ETS 300 347-1

A1

**This amendment A1 modifies
the European Telecommunication Standard ETS 300 347-1 (1994)**

iTeh STANDARD PREVIEW
(standard not final)
Signalling Protocols and Switching (SPS);
V interfaces at the digital Local Exchange (LE);
V5.2 interface for support of Access Network (AN);
Part 1: V5.2 interface specification

Figure 11: Link control functional model

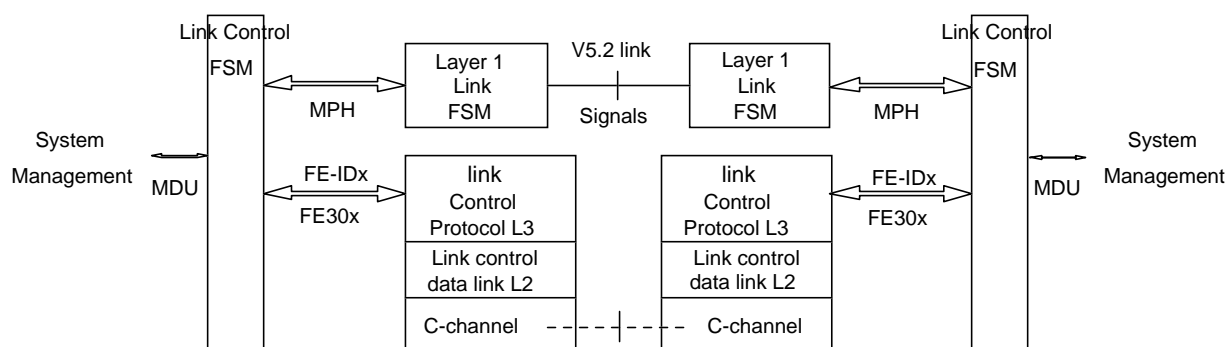
- Clause 16, figure 11: The invisible text is reconstituted from an earlier version.
- Subclause 16.2.4.5: A note is added about the sending of a notification to system management.

Page 46, figure 11

Add the formerly "invisible" text to figure 11:
